Hines and Jones Hall Refresh
ISU Bid #B0028696

12/23/2025

This Addendum issued prior to bidding, alters, amends, corrects or clarifies the Proposal Documents to the extent stated herein and does hereby become a part of the Proposal Documents, and will become a part of the Contract Documents of the successful bidder.

P204

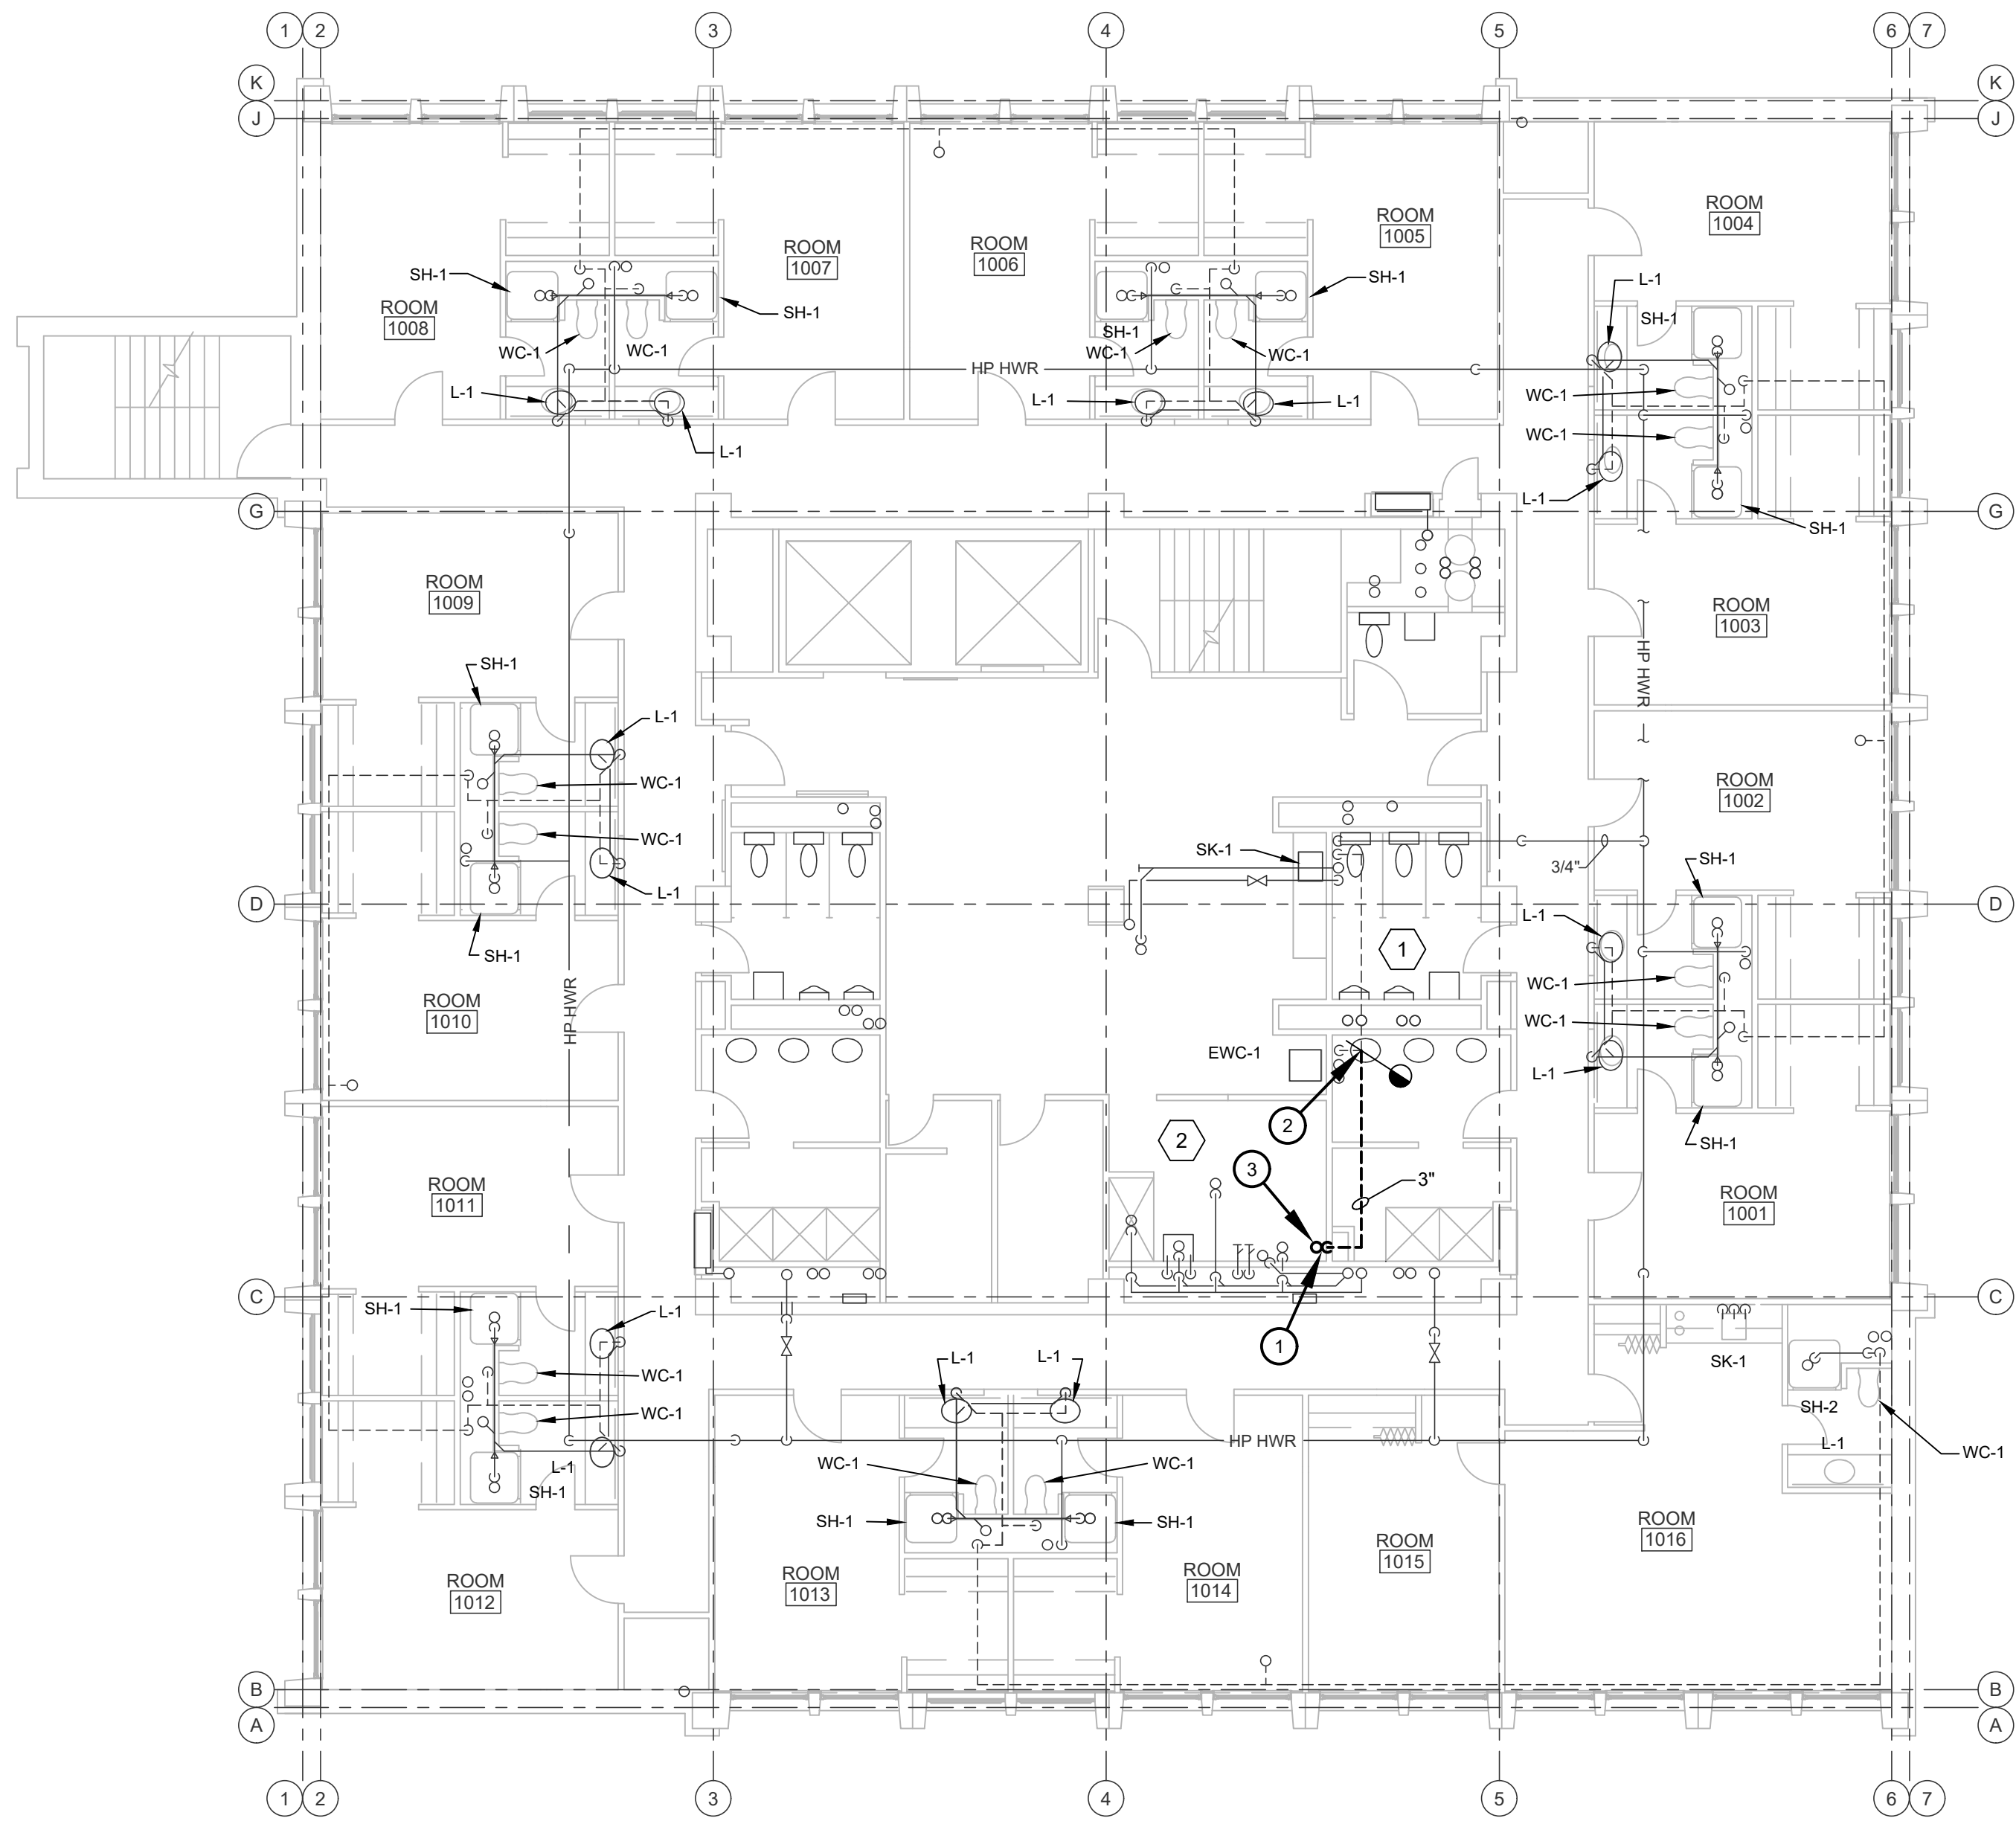
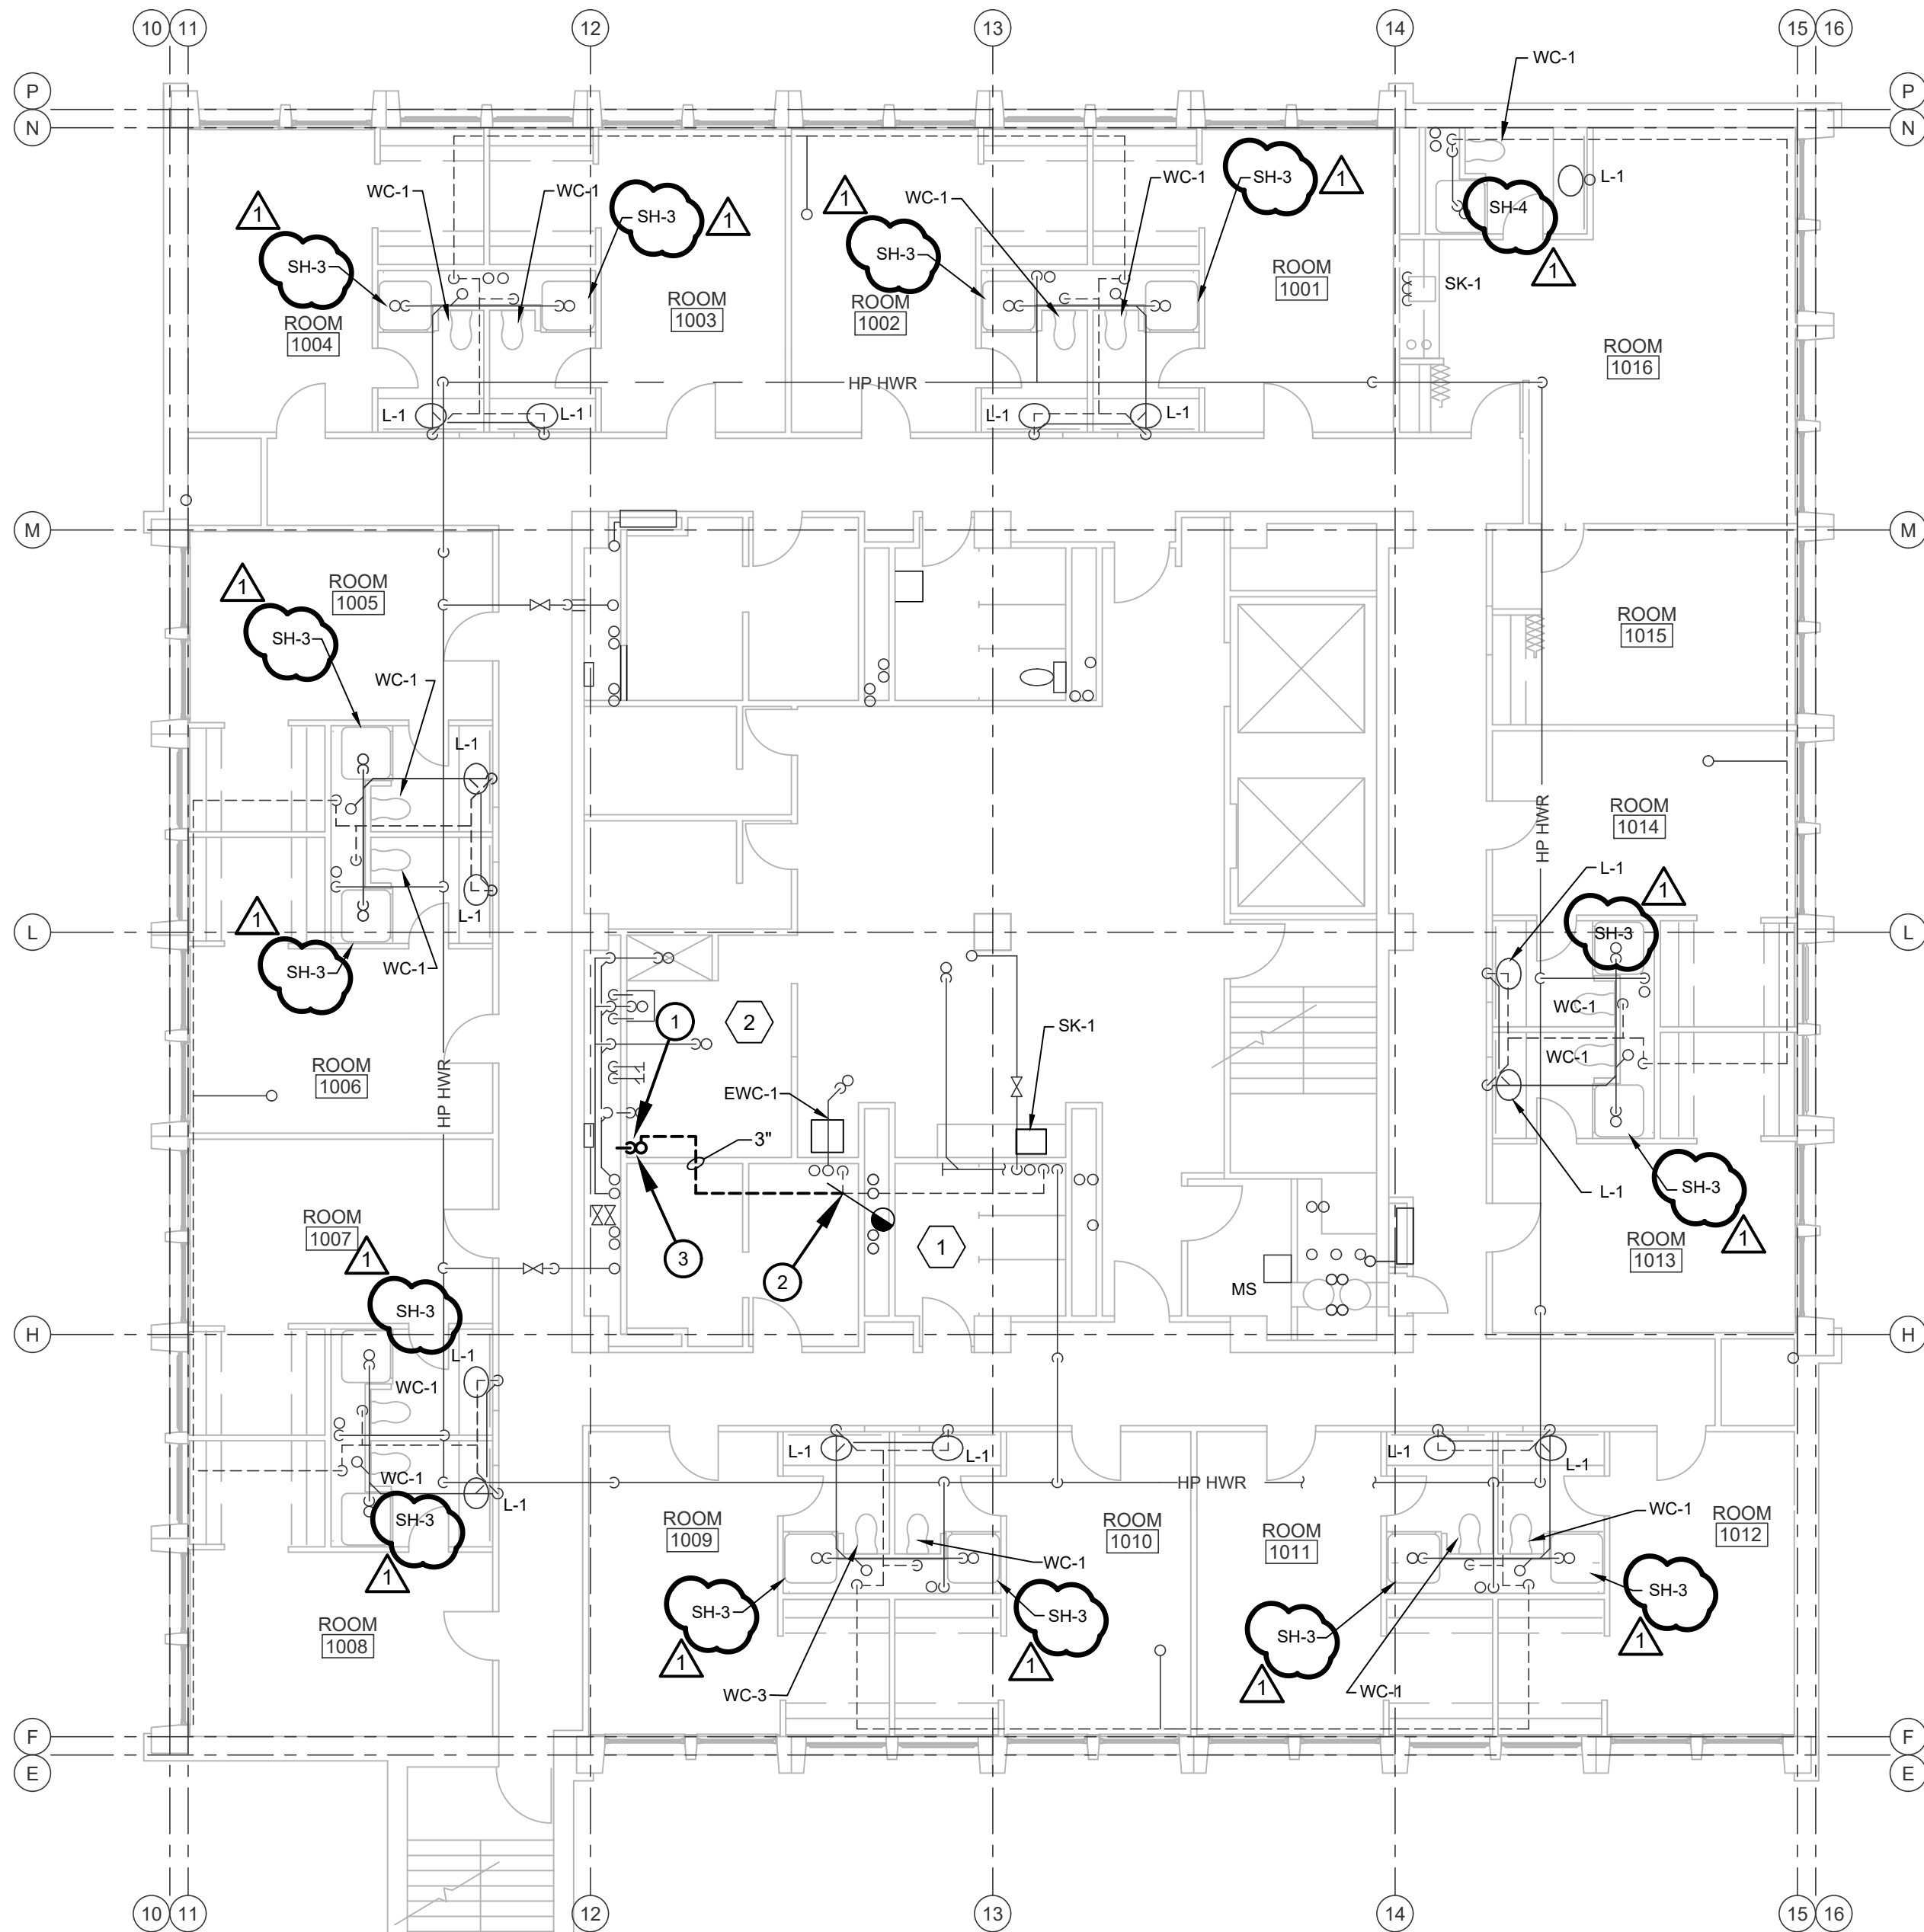
2. Drawing P204 – Tenth Floor – Plumbing
 - a. Identifies fixture types.
3. Drawing P301H – Hines Basement - Plumbing
 - a. Re-issued to clarify work to circulation pumps.
4. Drawing P301J – Jones Basement – Plumbing
 - a. Re-issued to clarify work to circulation pumps.
5. Drawing P401 – Schedules and Details – Plumbing
 - a. Re-issued to add Shower Cover Plate detail.
6. Drawing P621H – Hines Work Schedule – Plumbing
 - a. Re-issued to clarify work to shower valves.
7. Drawing P621J – Jones Work Schedule – Plumbing
 - a. Re-issued to clarify work to shower valves.
